SP2025-014: Site Plan for 2351 Harbor Heights Drive

PROJECT NUMBER: SP2025-014
PROJECT NAME: Site Plan for a Retail/Office Building
SITE ADDRESS/LOCATIONS: 2351 HARBOR HEIGHTS DR

CASE CAPTION: Discuss and consider a request by Jimmy Strohmeyer of Strohmeyer Architects, Inc. on behalf Dan Bobst of HH Retail Center, LP for the approval of a Site Plan for a Retail/Office Building on a 2.893-acre parcel of land identified as Lot 2, Block B, Harbor District Addition, City of Rockwall, Rockwall County, Texas, zoned Planned Development District 32 (PD-32), situated within the IH-30 Overlay (IH-30 OV) District, addressed as 2351 Harbor Heights Drive, and take any action necessary.

DEPARTMENT	REVIEWER	DATE OF REVIEW	STATUS OF PROJECT
PLANNING	Bethany Ross	04/24/2025	Needs Review

SITE PLAN
ELECTRICAL LIGHTING

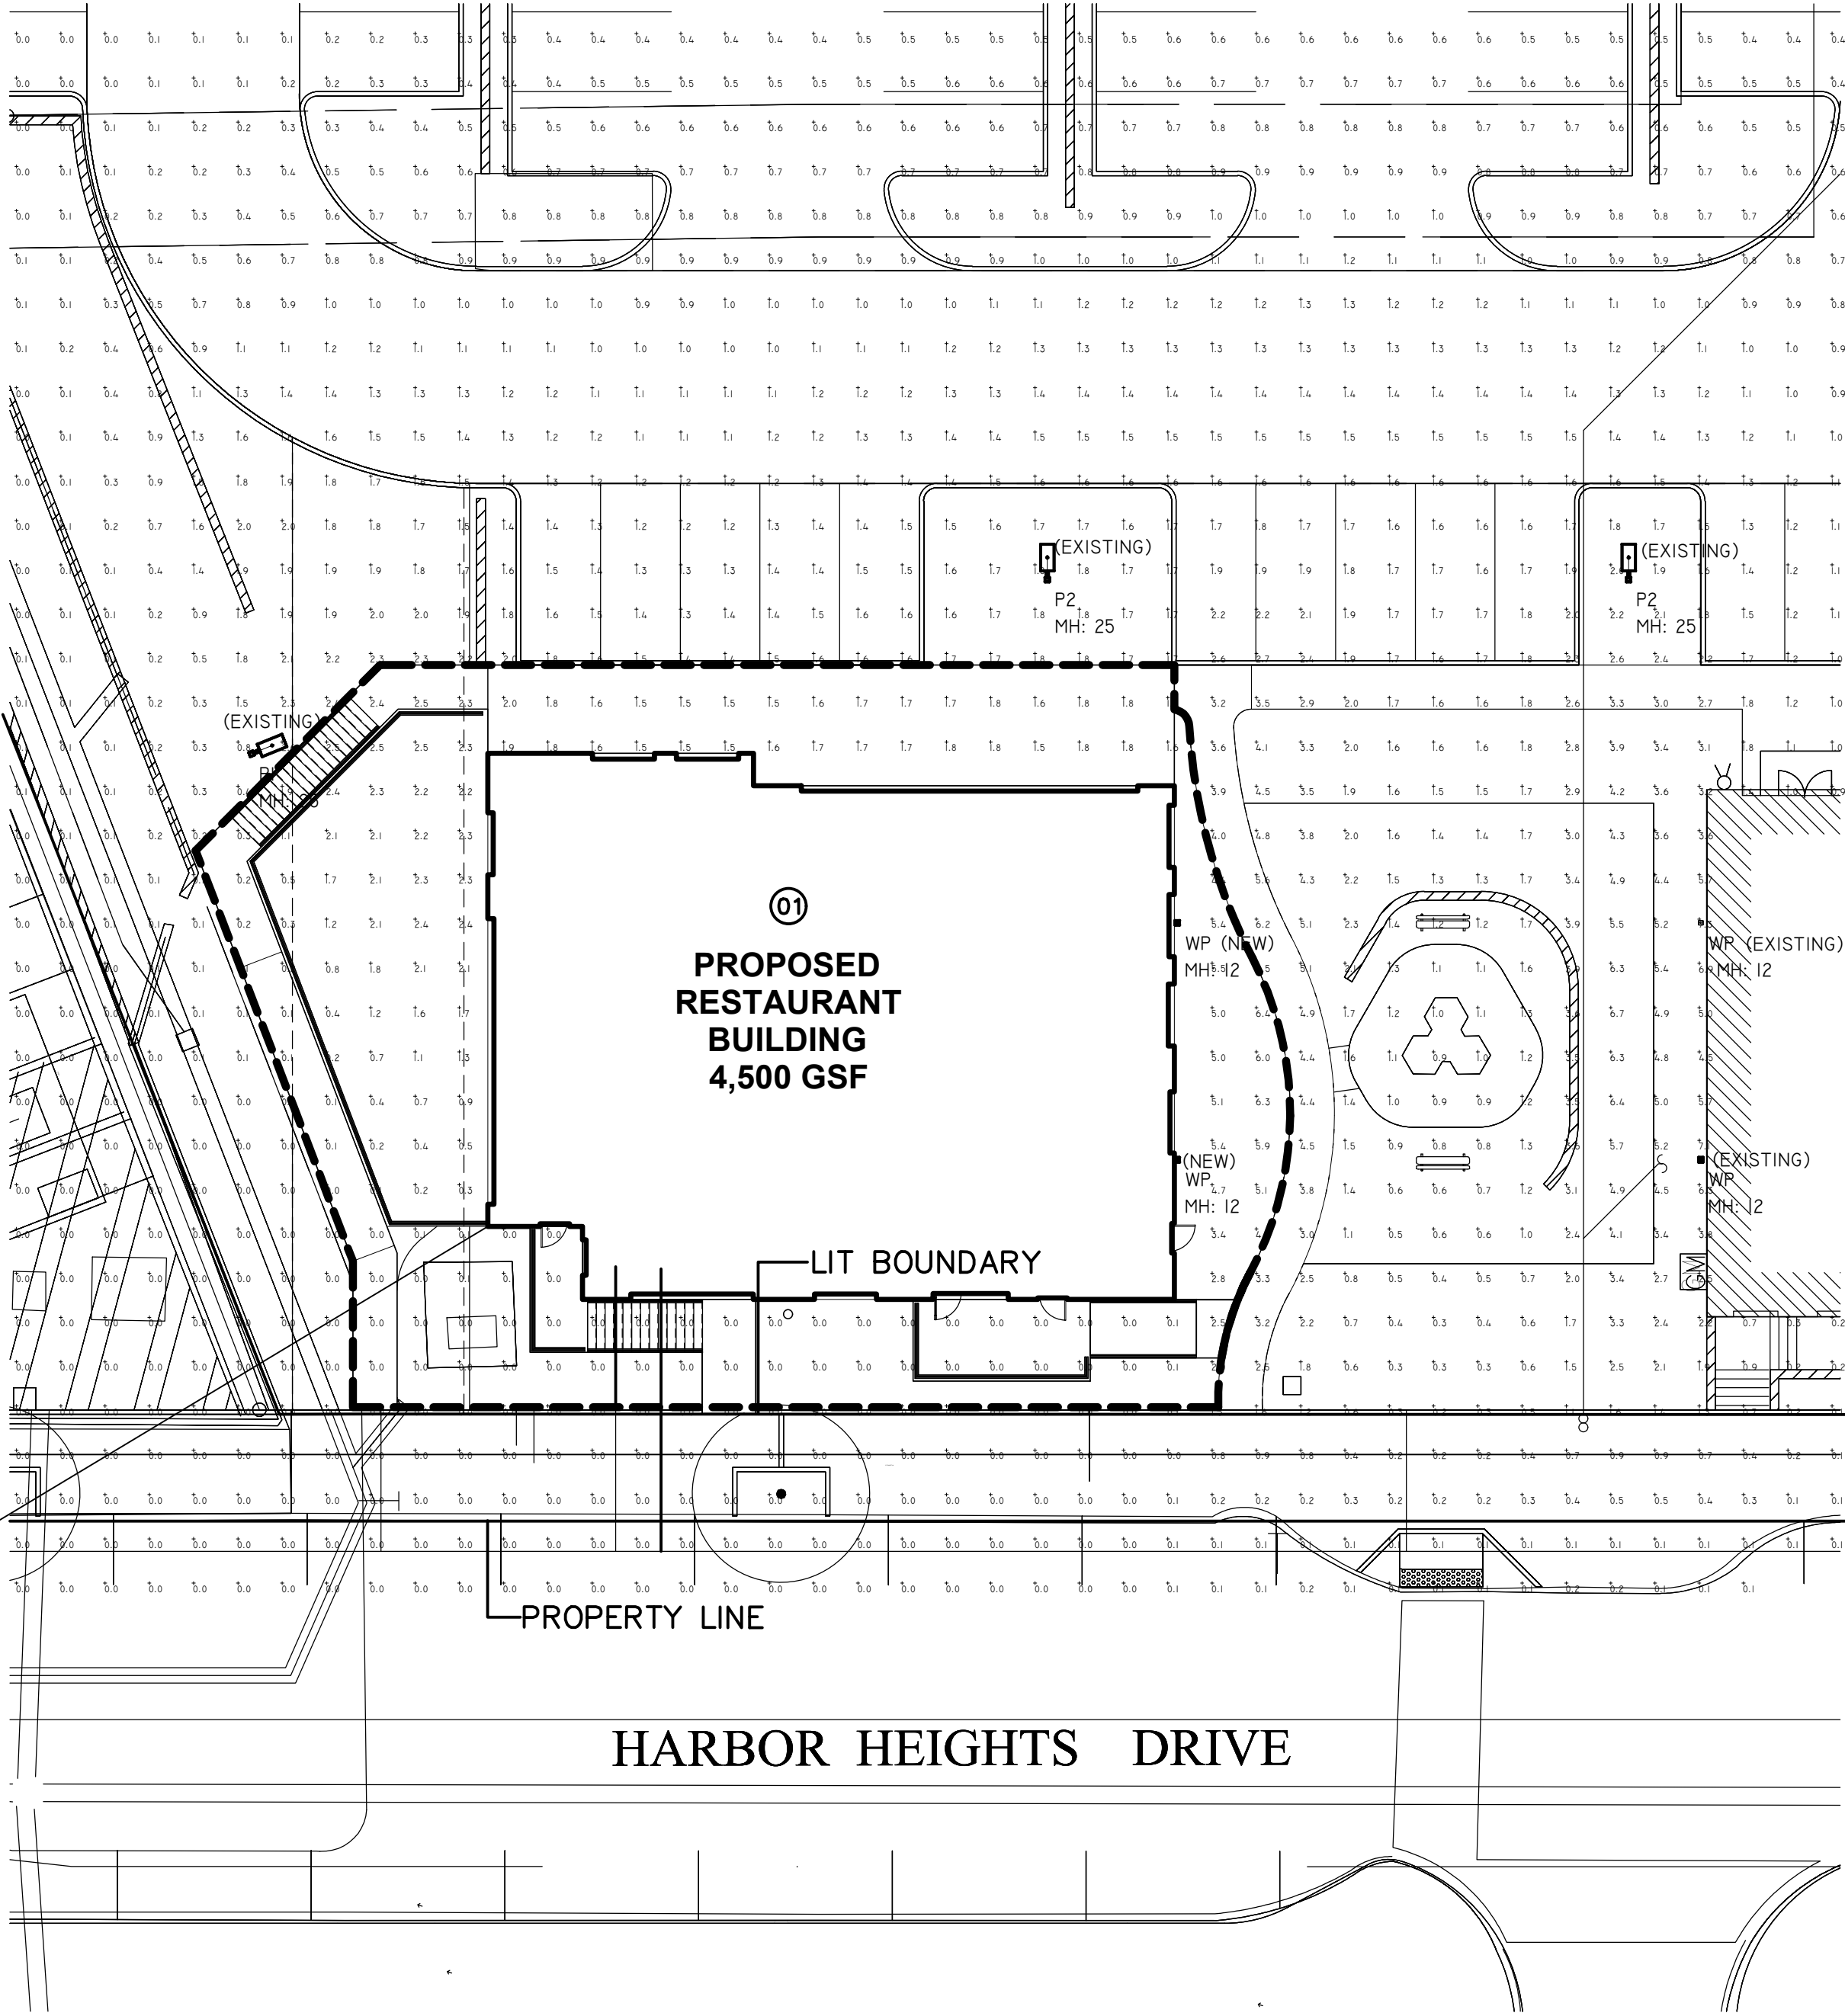
(2) Please provide lighting cut sheets that indicate the wattage for each exterior lighting fixture. Light sources (e.g. light bulbs) shall be oriented down and toward the center of the site or shielded so as to not be visible from the property line. (Subsection 03.03.A, of Article 07, of the UDC)

1 SITE PLAN
1" = 10'-0"

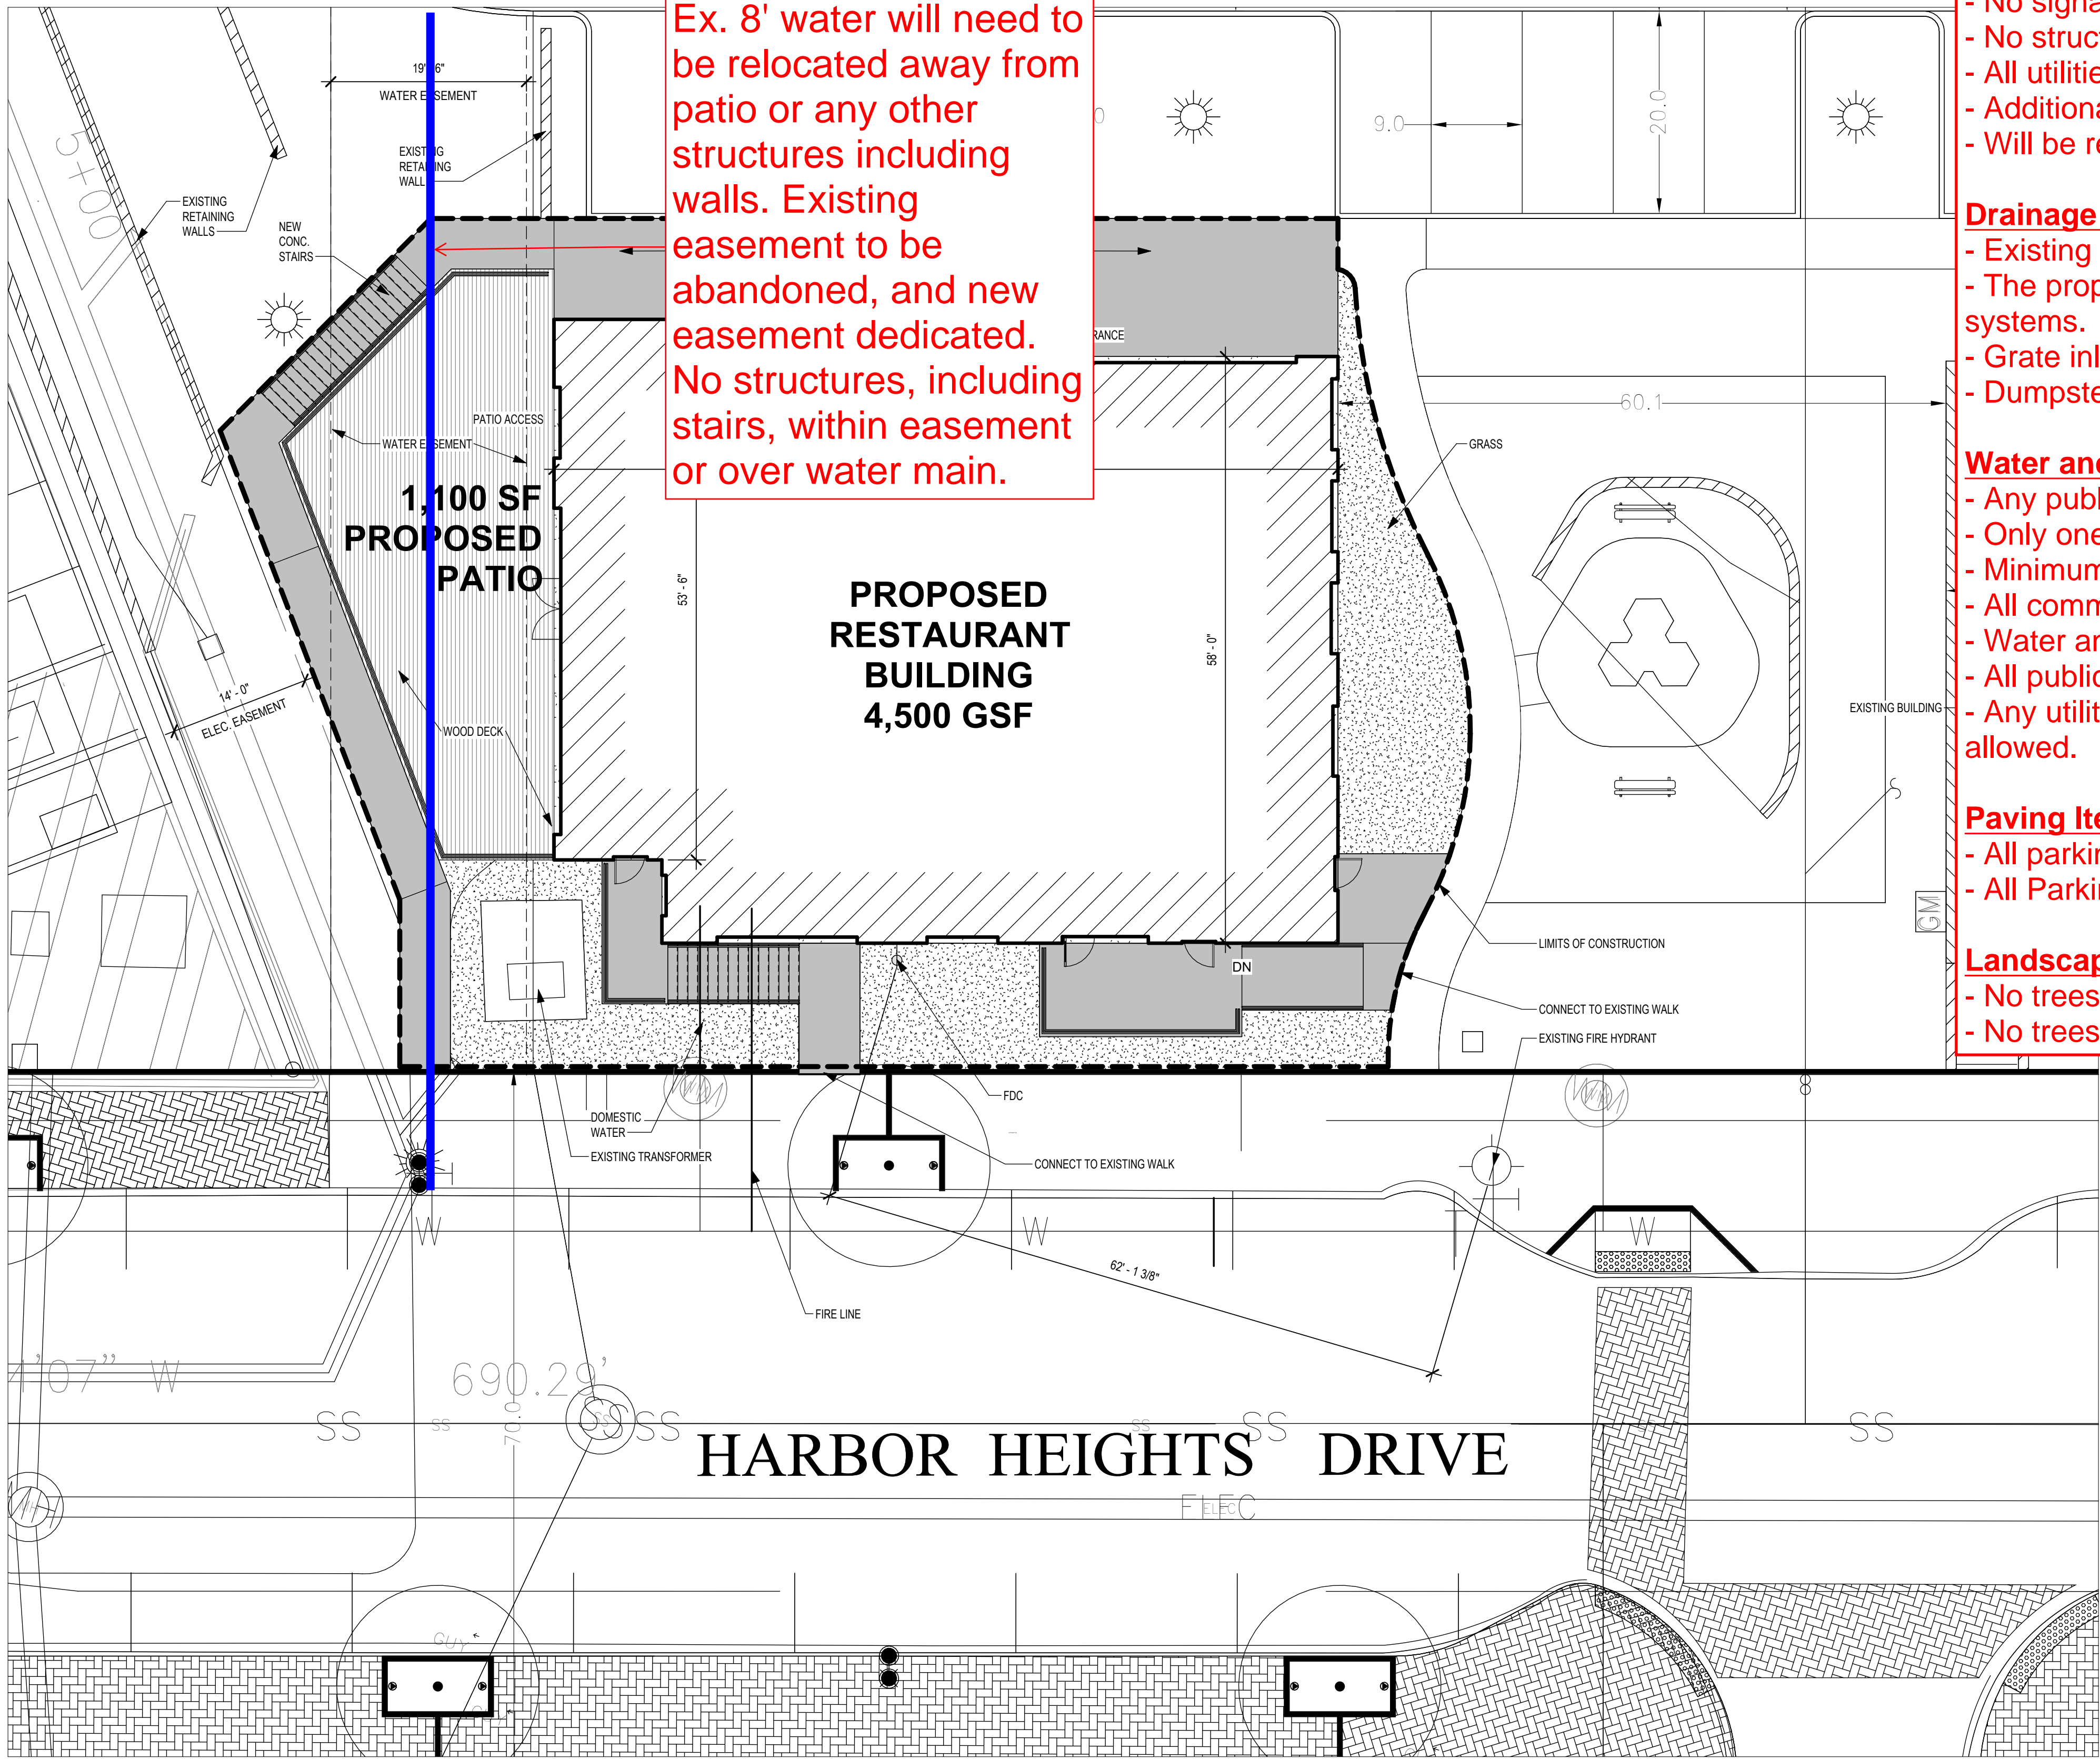
(1) Pad mounted utility equipment, and air conditioning units, shall be screened from horizontal view from any adjacent public street and from any adjacent property. Utility equipment and air conditioning units shall be screened utilizing plantings berms, or walls matching the main structure. (Subsection 01.05.C, Article 05, of the UDC) Please indicate on your site plan if there are any pad mounted utility equipment. Utility equipment will be subject to screening if found later at engineering or building permit.

(3) The maximum square footage for this building is 4,000 SF according to the PD Development Plan [Ordinance No. 19-25]. This will be a variance to the PD Development Plan.

04/22/2025: 1. New construction to meet the utility, drainage, and grading requirements as constructed with the Harbor Heights Restaurant and Retail as-built plans.
2. All drainage is required to drain to existing drop inlet. No drainage allowed to Harbor Heights.
3. Ex. 8' water will need to be relocated away from patio or any other structures including walls. Existing easement to be abandoned, and new easement dedicated. No structures, including stairs, within easement or over water main.
